**Special Plan Commission – Meeting Agenda
Thursday, June 13, 2024
Village Hall, 65 Cedar Avenue**

RE: 801 Tower Drive – Gas Station

SUBJECT: 801 Tower Drive – New Gas Station-Plan Review #2- Approved with Conditions

Sheet No.
C-2.0

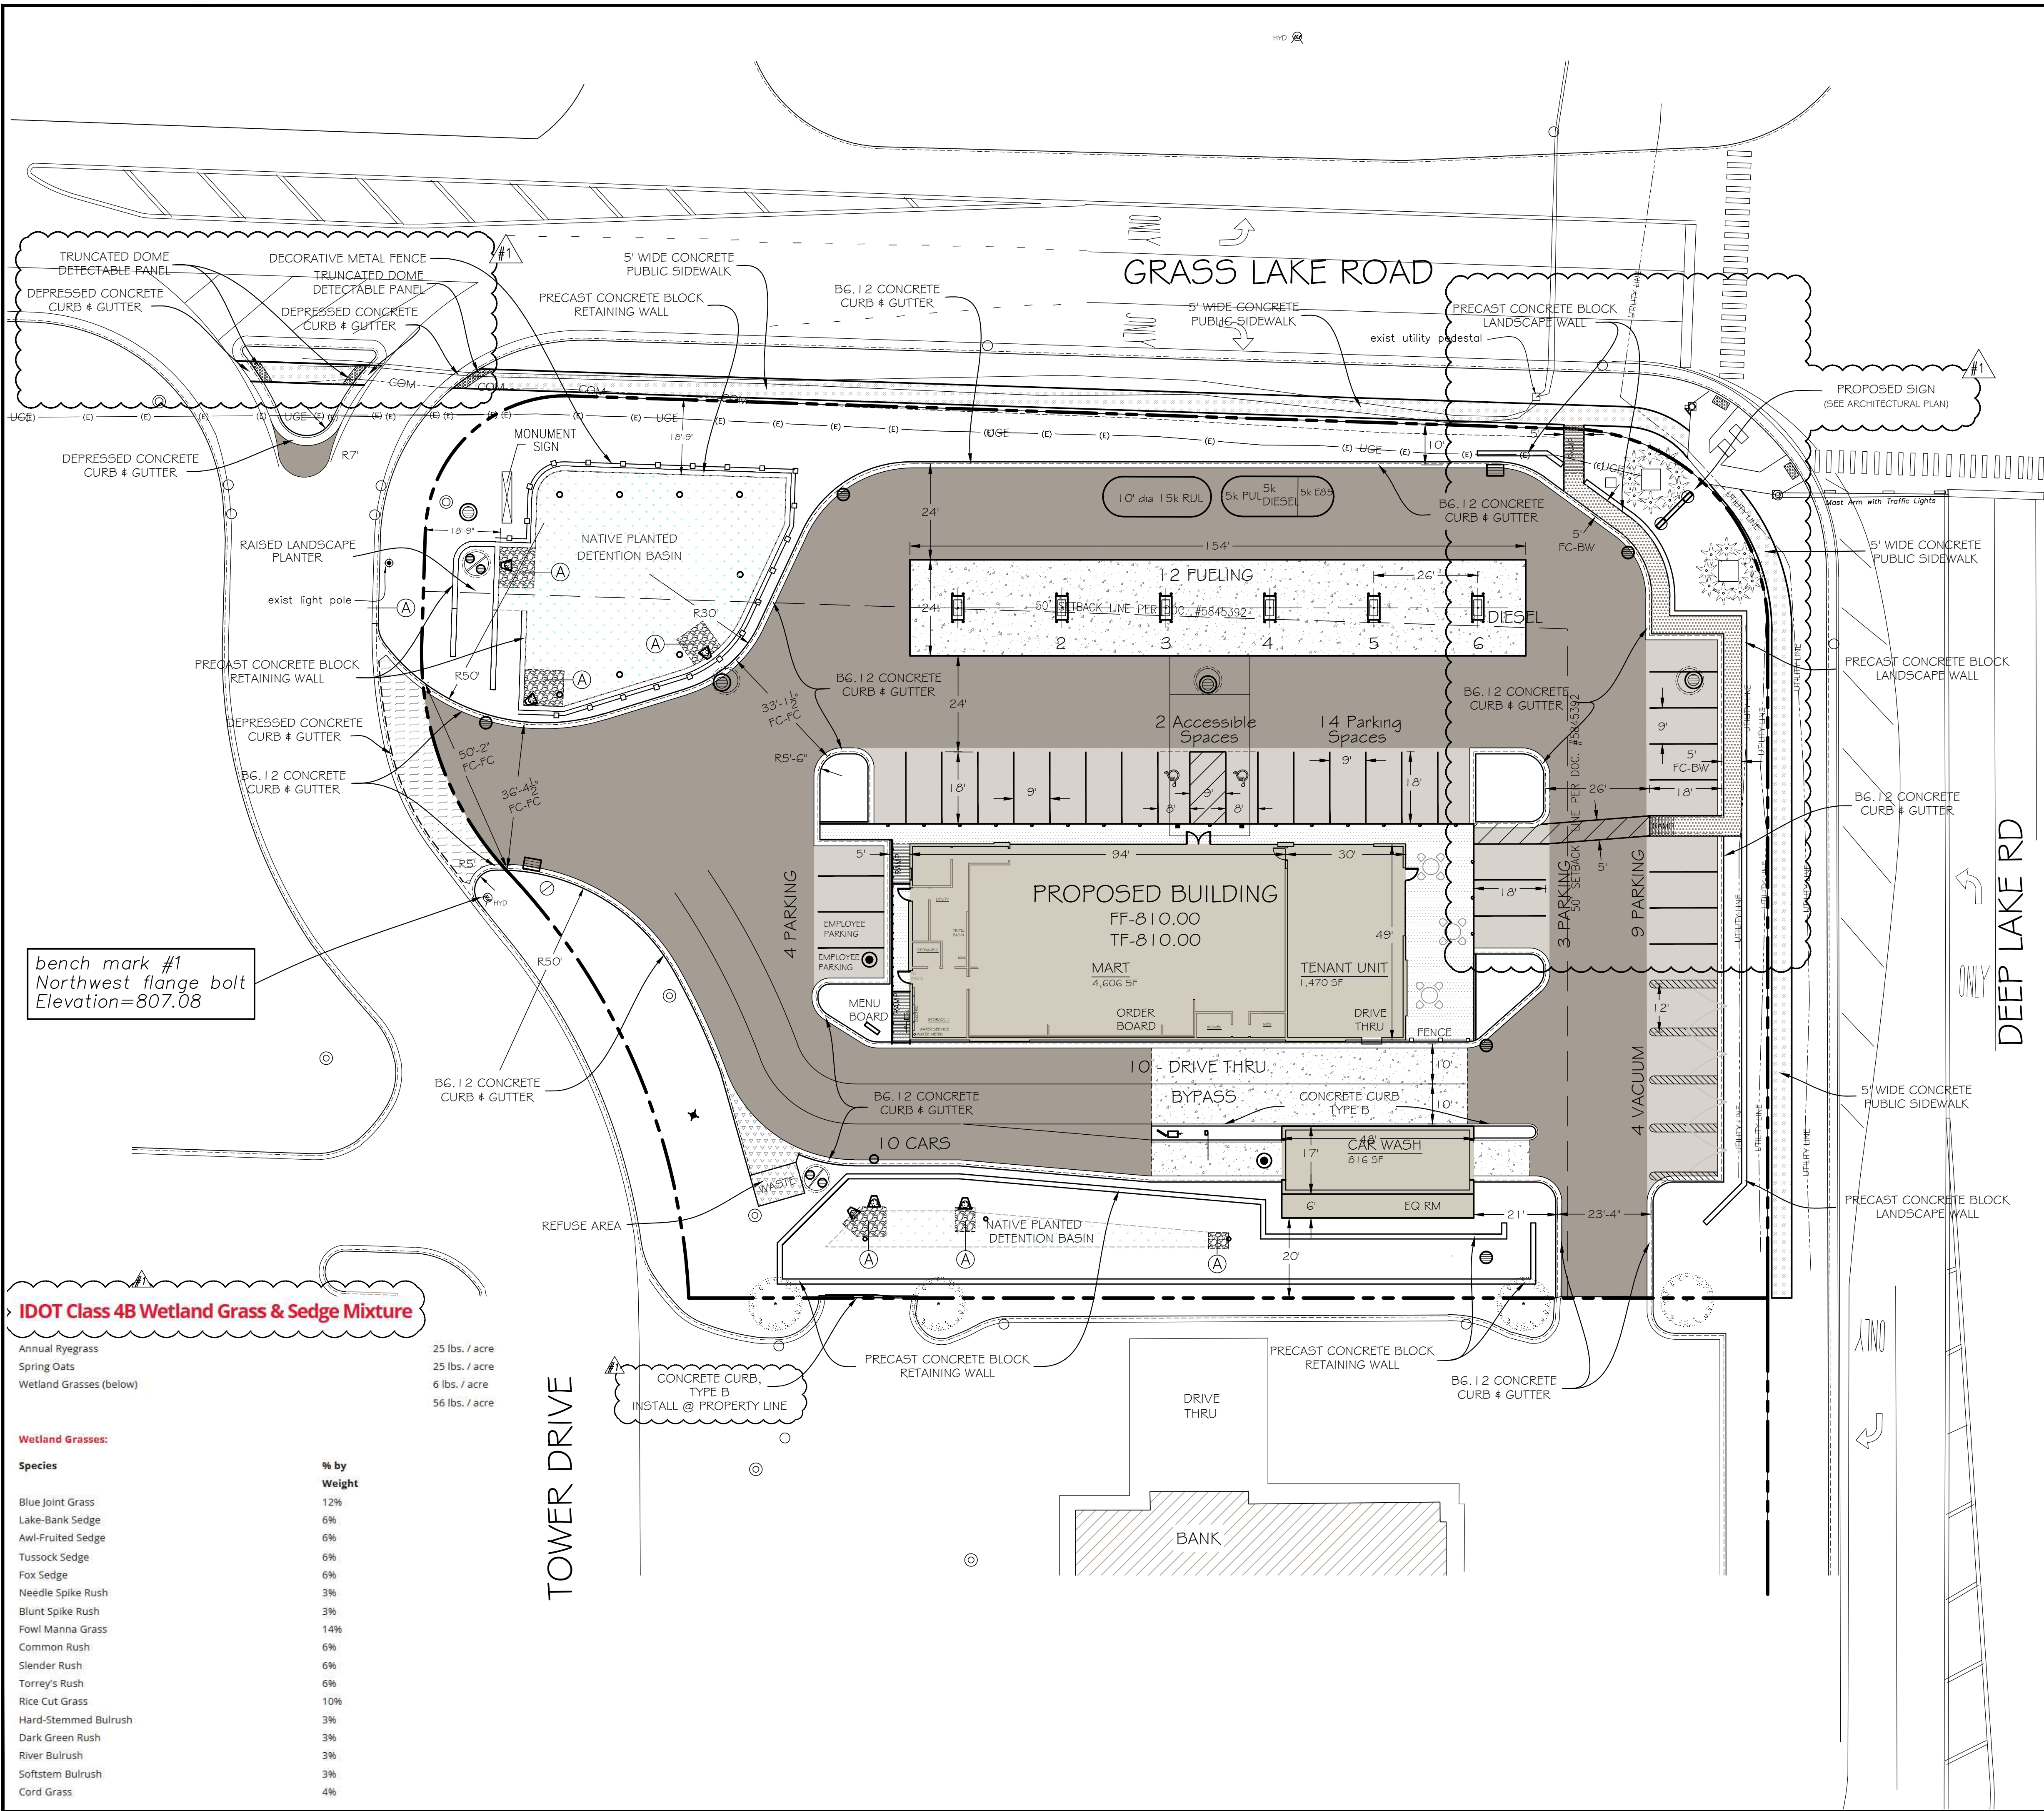
1. Show all 20-foot, 10-foot, and 15-foot utility easements see sheet SUR-1.
2. Show existing water utilities along with the Tower Drive water main crossing.

Sheet No.
C-7.0
NJ Project No.
24-7543

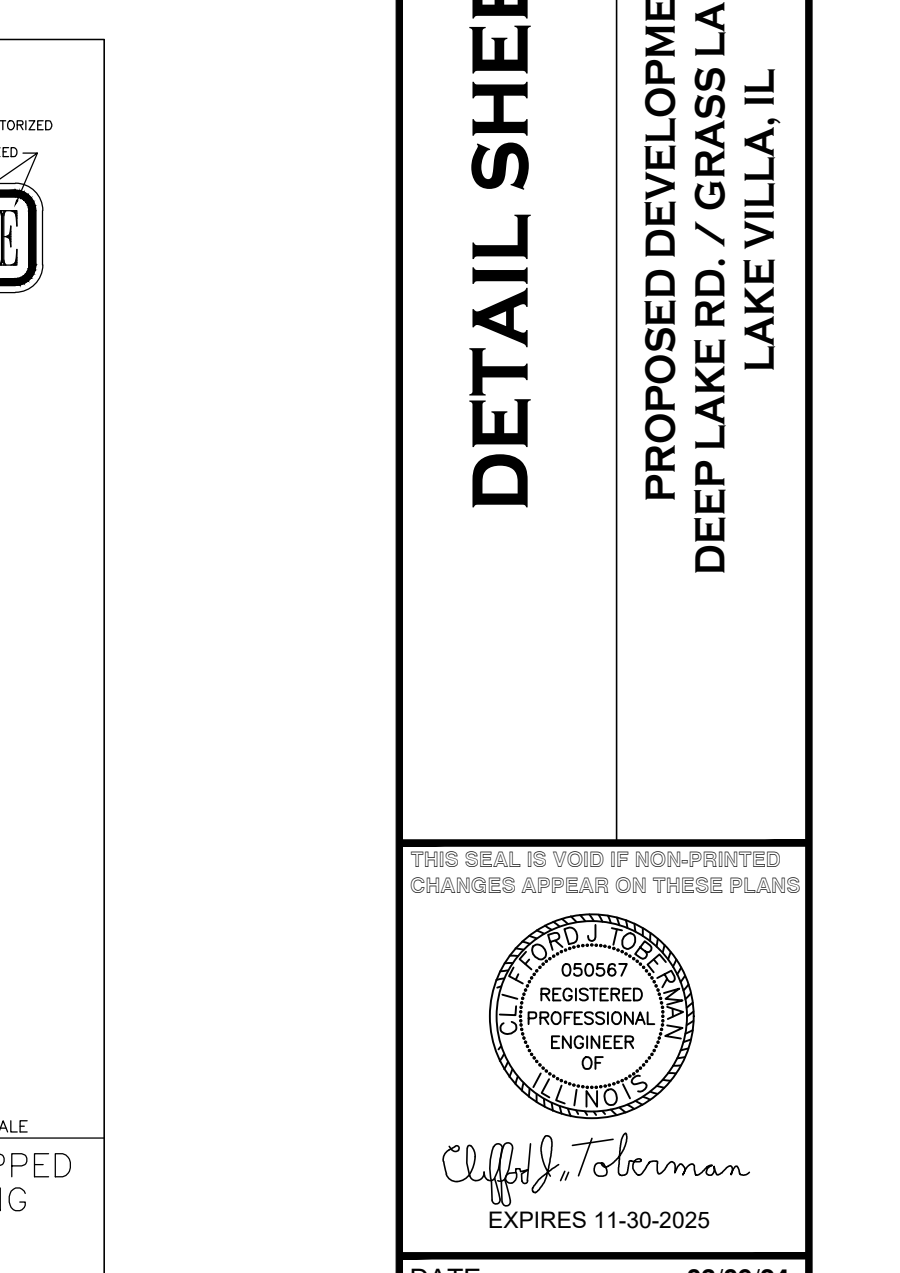
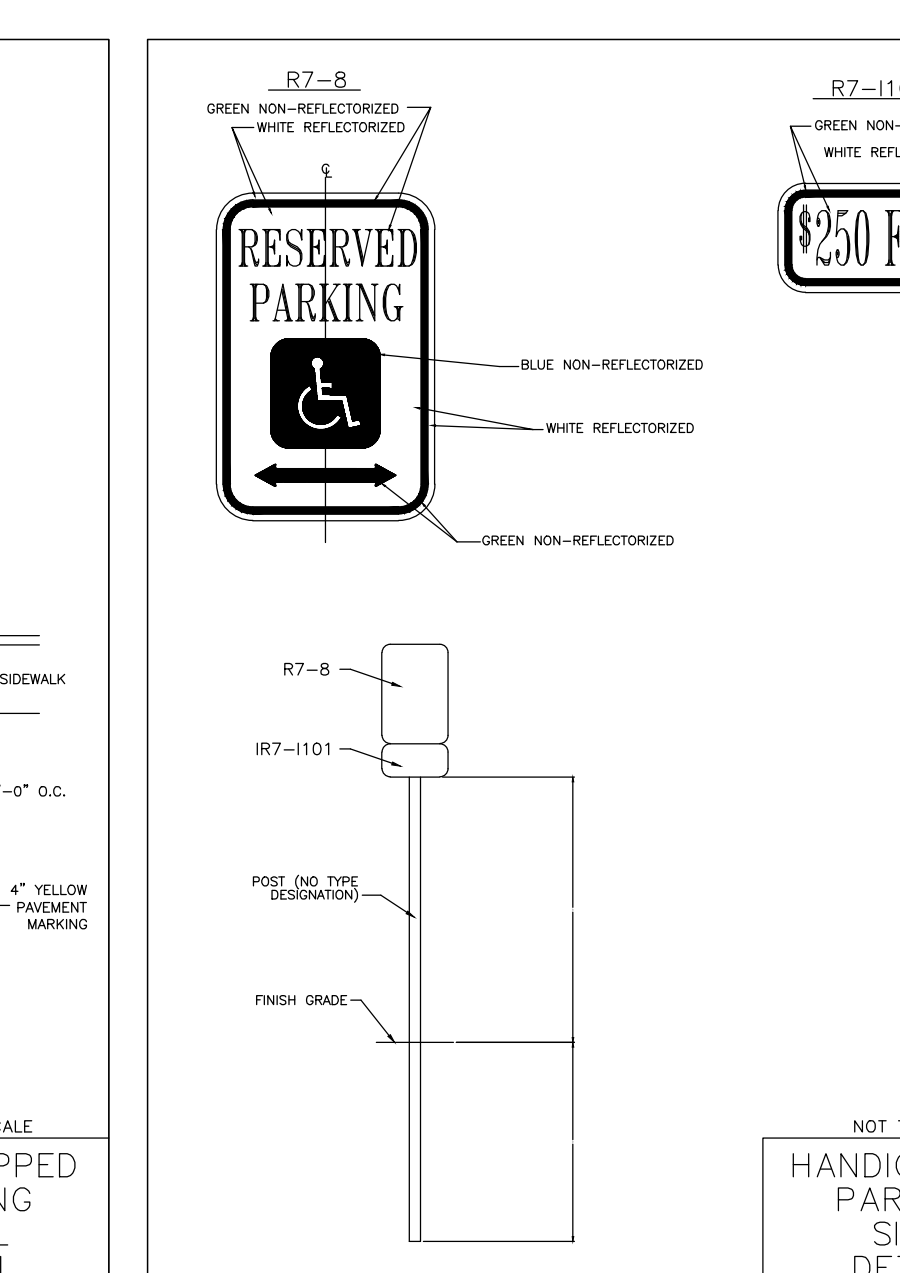
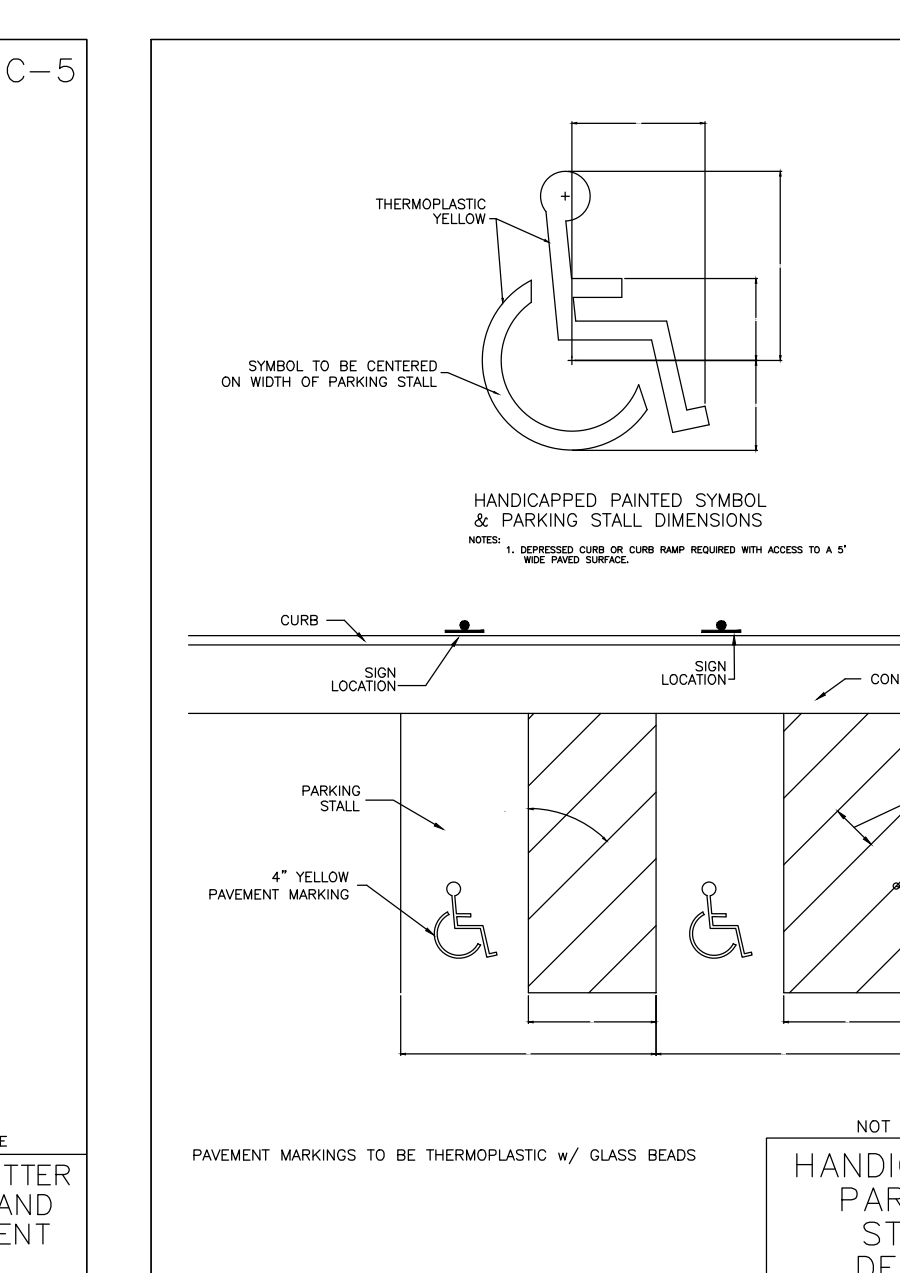
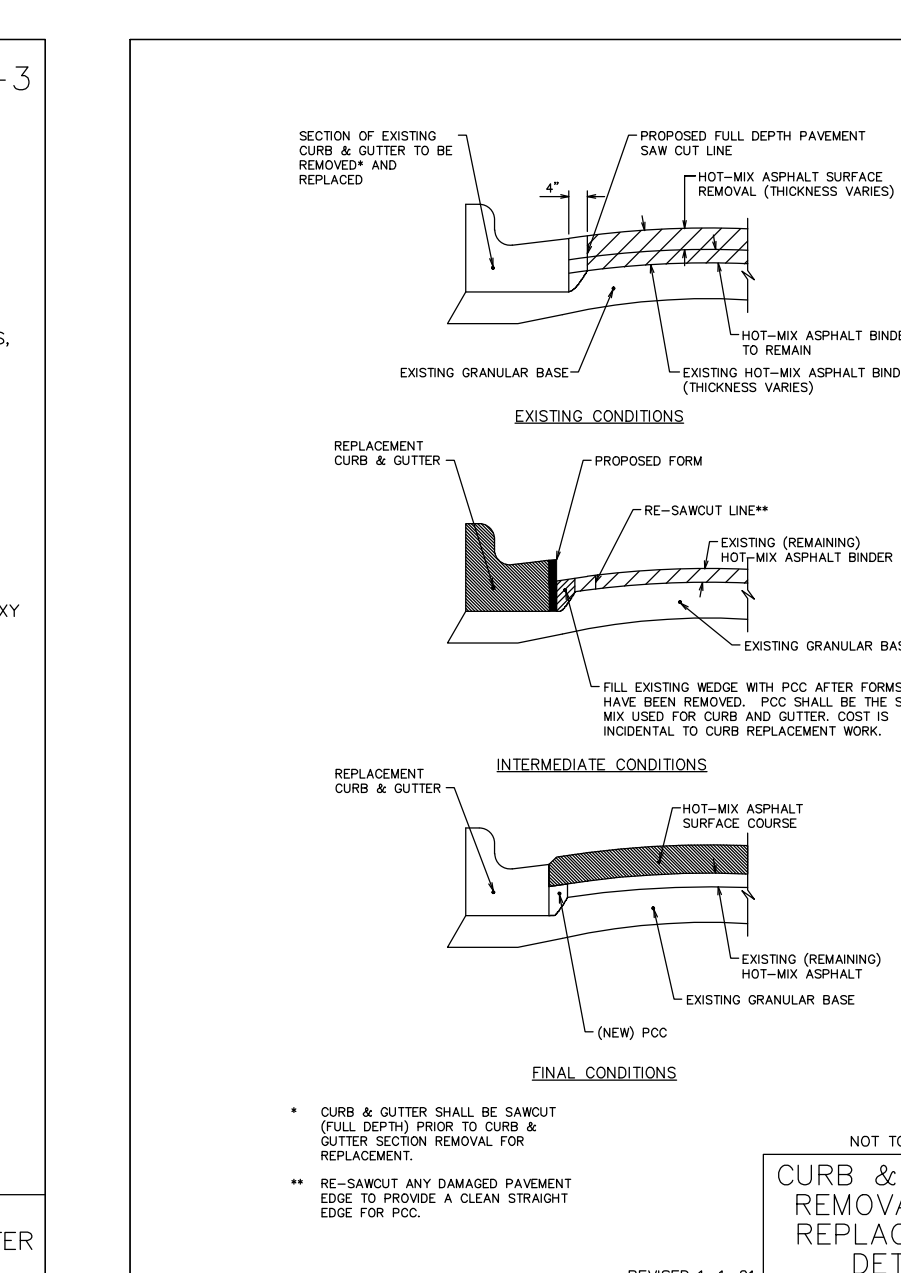
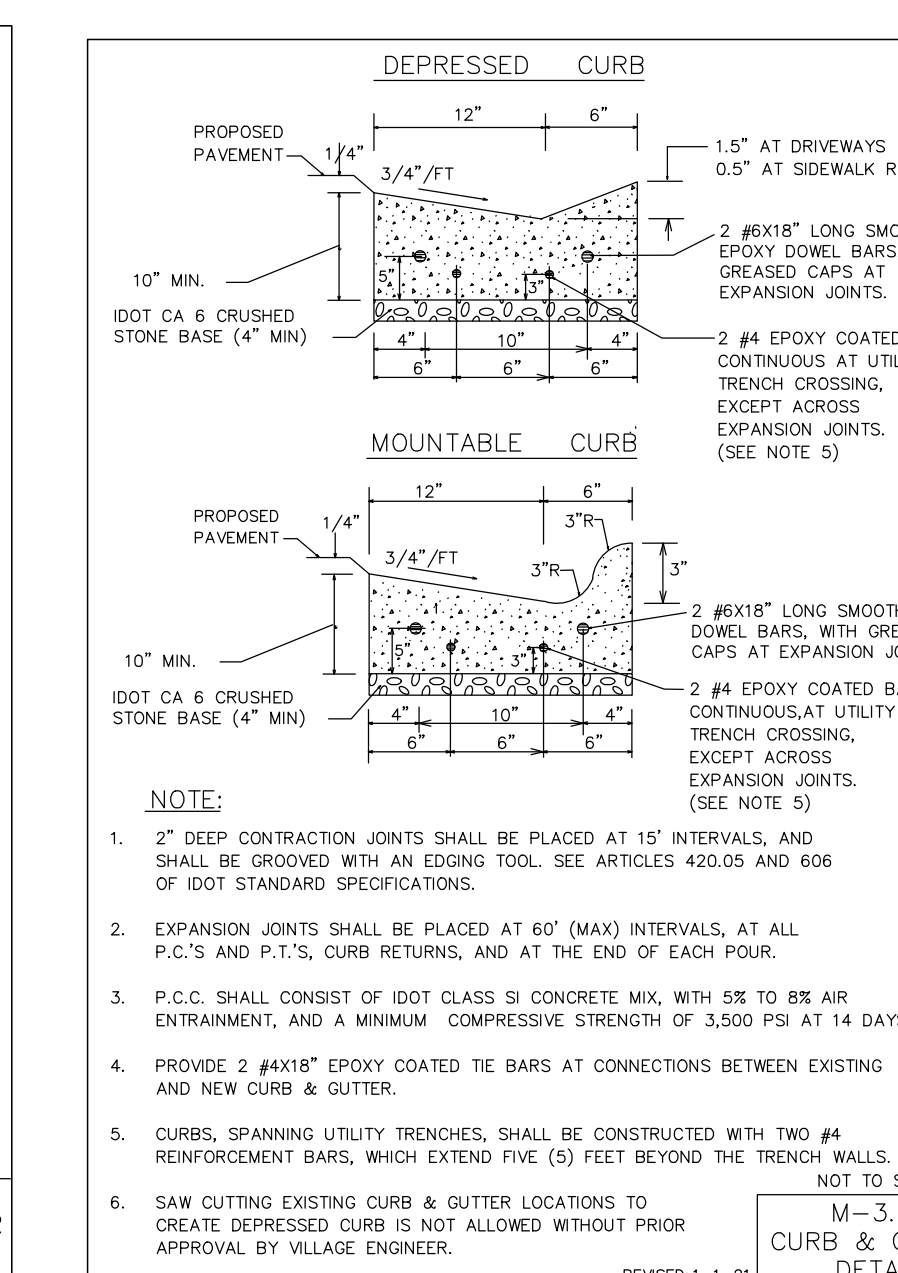
- a) Water Service Connection Detail. The following are the only acceptable products:
 - a. Curb Box: Mueller H 10300 Minneapolis Style
 - b. Curb Stop: Muller 25454
 - c. Corporation Stop: Mueller 25000 series
 - d. Service Saddle: Stainless Steel Fulle Saddle Smith-Blair 372
